**Addendum No. 1**

**Project:** Child Care Upgrades  
**Bedford North Lawrence High School Career Center**  
Bedford, Indiana

**Project No:** 1616.03

**Date:** 3/10/16

Sheet  
**A-202**  
Enlarged Floor Plan - New Work

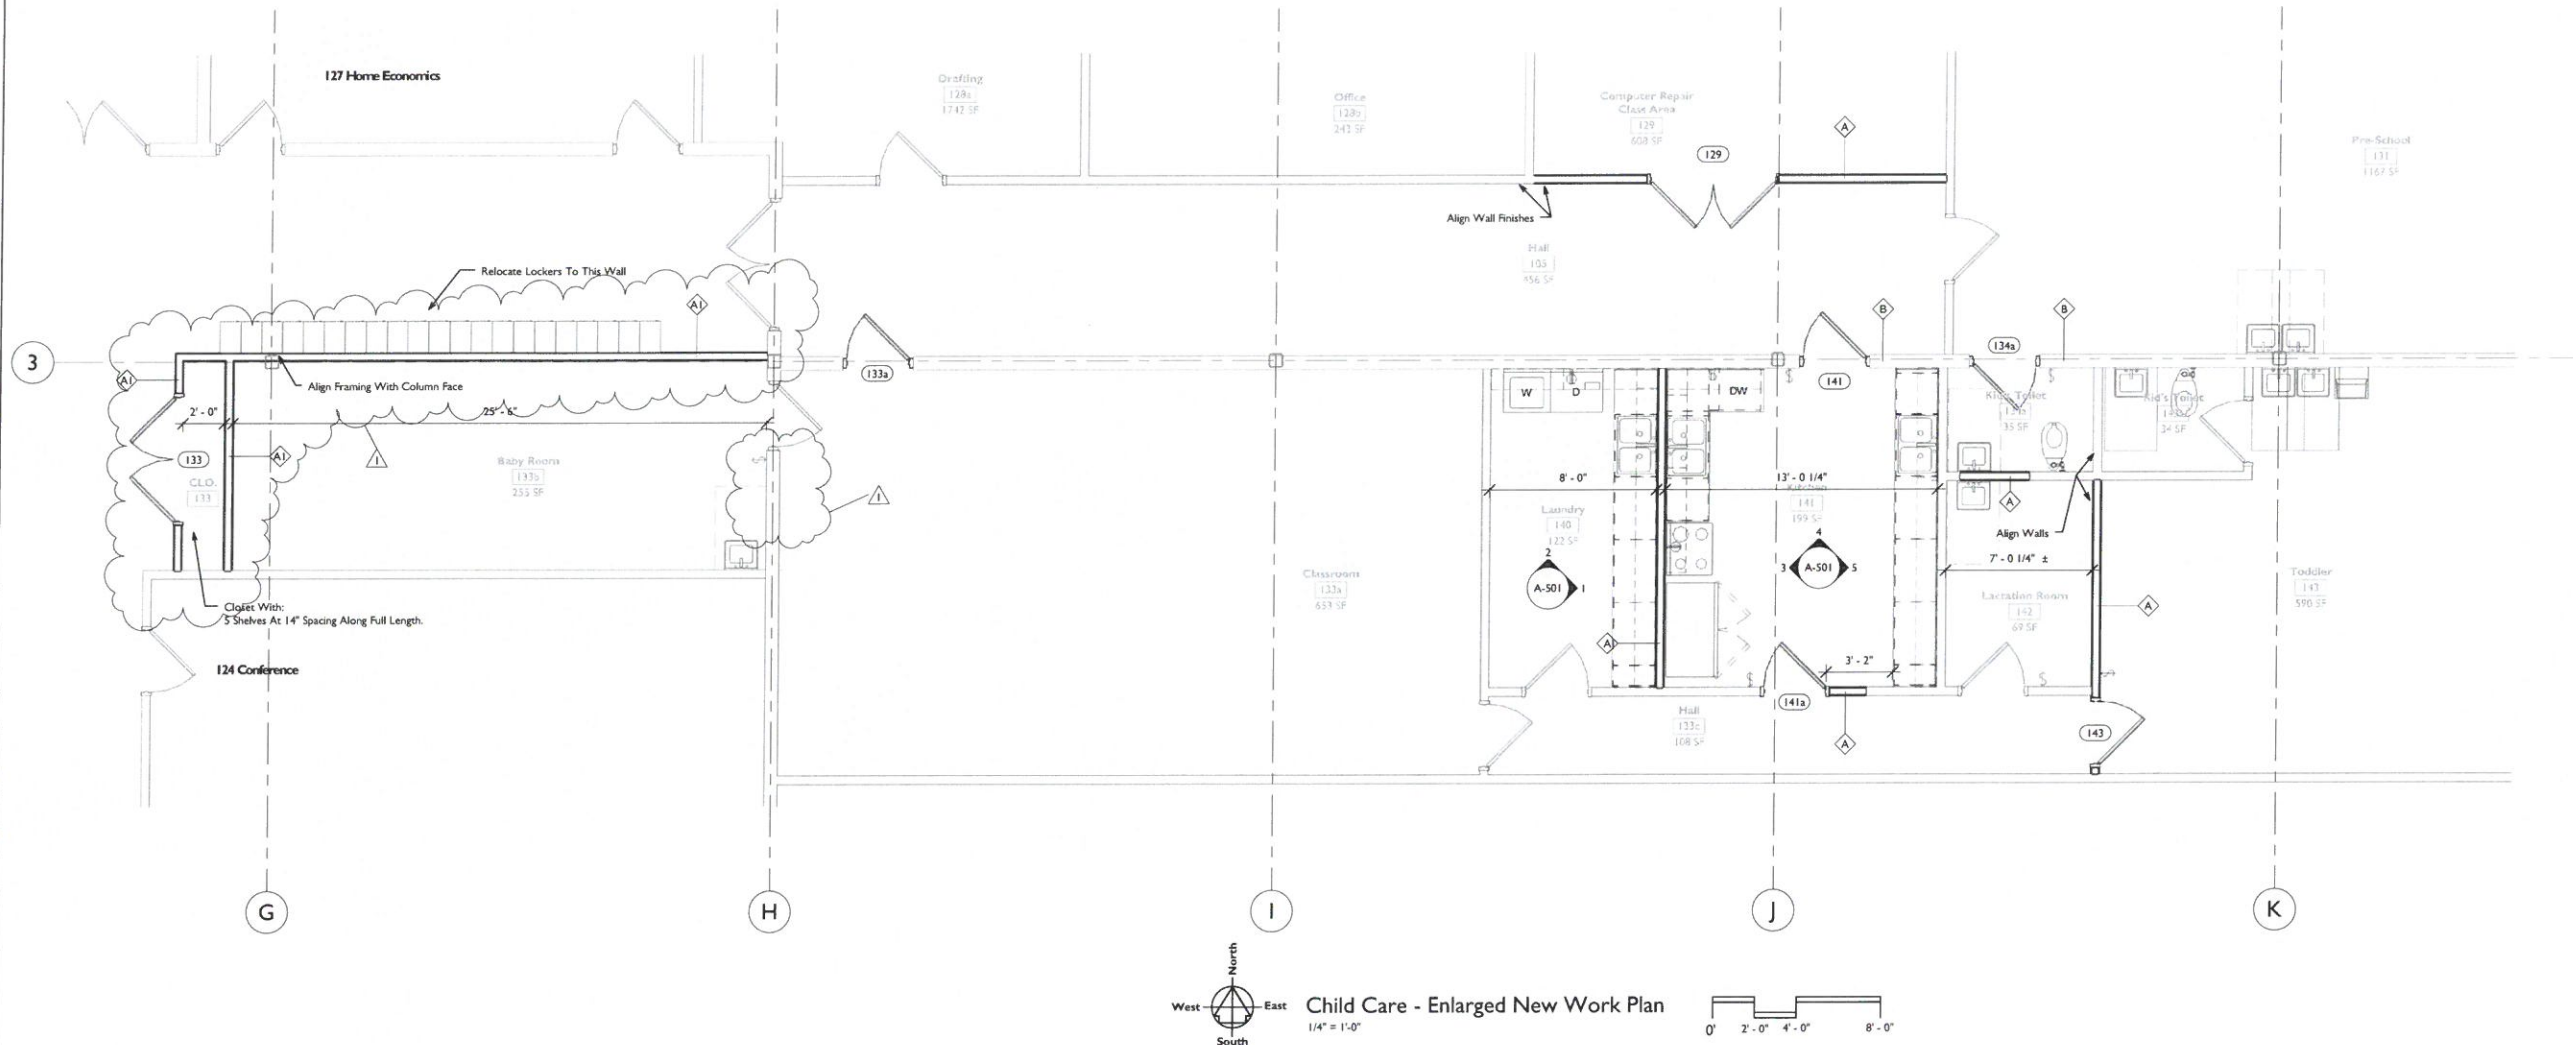
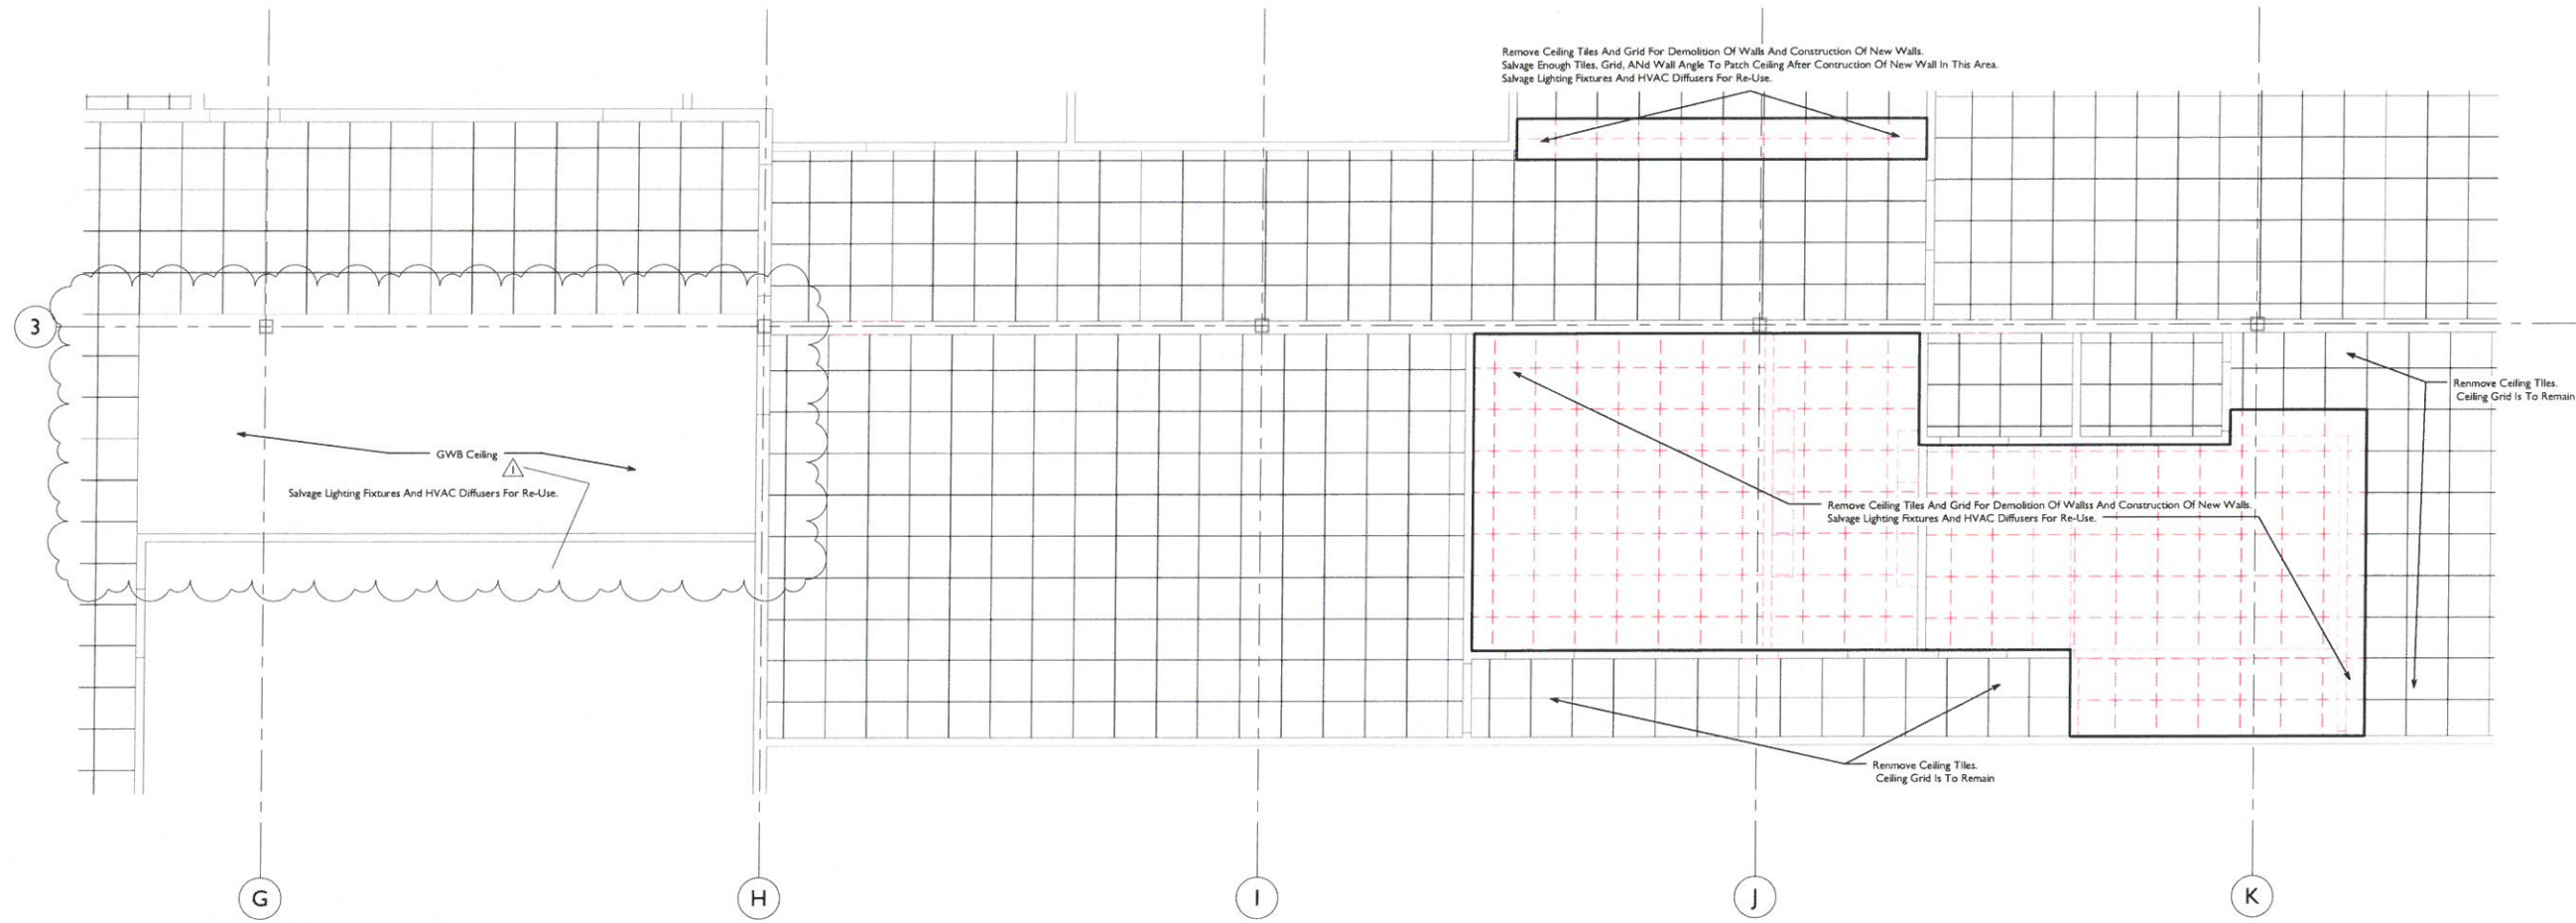
1. G-101,A-202,A-901,I-101  
Delete new aluminum framed window between Classroom 133a and baby Room 133b
2. A-202,A-401,A-402,A-901,I-101  
Change Ceiling in New Bay Room 133b and Closet 133 to existing drywall ceiling.  
This existing drywall ceiling is to remain and new wall are built under it. Wall type AI is added to sheet A-901 to depict this new wall condition
3. A-901  
Wall Types - At the Contractor's option, the use of wood studs is acceptable as a substitute for the detailed metal studs

**5 Aluminum Storefront Window Details**  
3" = 1'-0"

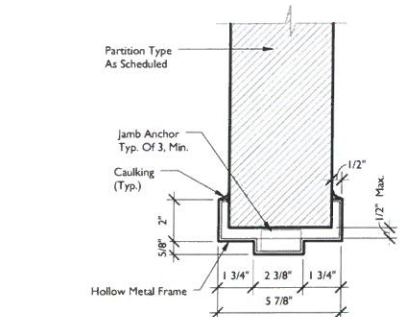
1. Questions
2. Omit new window and blinds into Baby Room 133b from Classroom 133a.
3. Existing GWB ceiling in new Baby Room 133b and new Closet 133 is to remain. New walls below are to be construction below ceiling. See revised wall type A1 on sheet A-901.
4. Tour
